APPLICATION FOR CERTIFICATE OF APPROPRIATENESS

1232 Armstrong Ave. 37917

Staff Report

File Number: 1-E-21-HZ

TITLE: ELEVATIONS

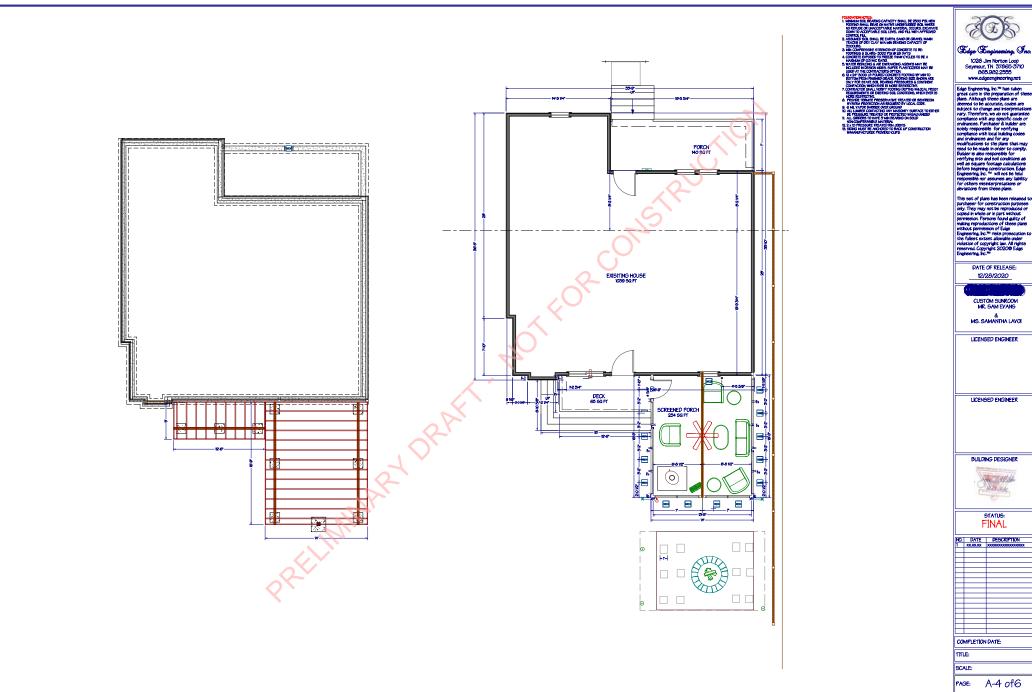
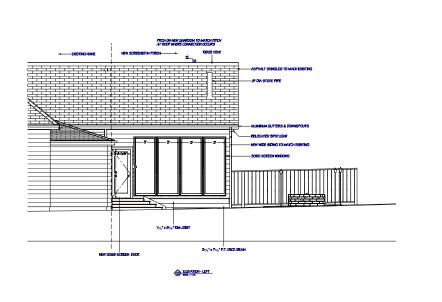
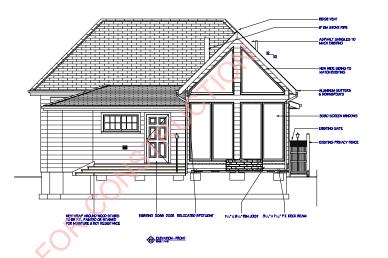
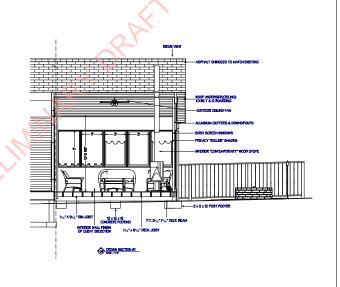
- 5. The applicant has proposed to extend the existing rear gable for the porch roof, which creates a large massing somewhat disproportionate to the house's rear elevation. Stepping down the porch gable between 8"-1' below the main gable would differentiate the new porch from the historic house and reduce the overall massing of the addition.

- 6. Guidelines note that the addition should be distinguishable from the historic building, but compatible in massing, materials, size, texture, and scale. Overall, the massing, materials, and details of the addition are appropriate for a new enclosed porch on a non-visible elevation. Retaining the existing cornerboard detail on the house's northeast corner would preserve a historic feature and serve to differentiate the porch addition on the side elevation.

- 7. The application describes "wide siding to match house" for the small sections of siding (primarily on the north side of the addition). The existing house is asbestos or a similar synthetic siding with a wide exposure. In staff's opinion, both smooth-finished HardiePlank or wood siding would be appropriate, as the scope of work is a new addition, the siding section is very limited in size, and would not not visible from the street.

Staff recommends approval of the work as proposed with the following conditions: 1) retain the northeast cornerboard; 2) step down the porch gable between 8" and 1' below the main gable; 3) provide final siding specifications to staff for approval.
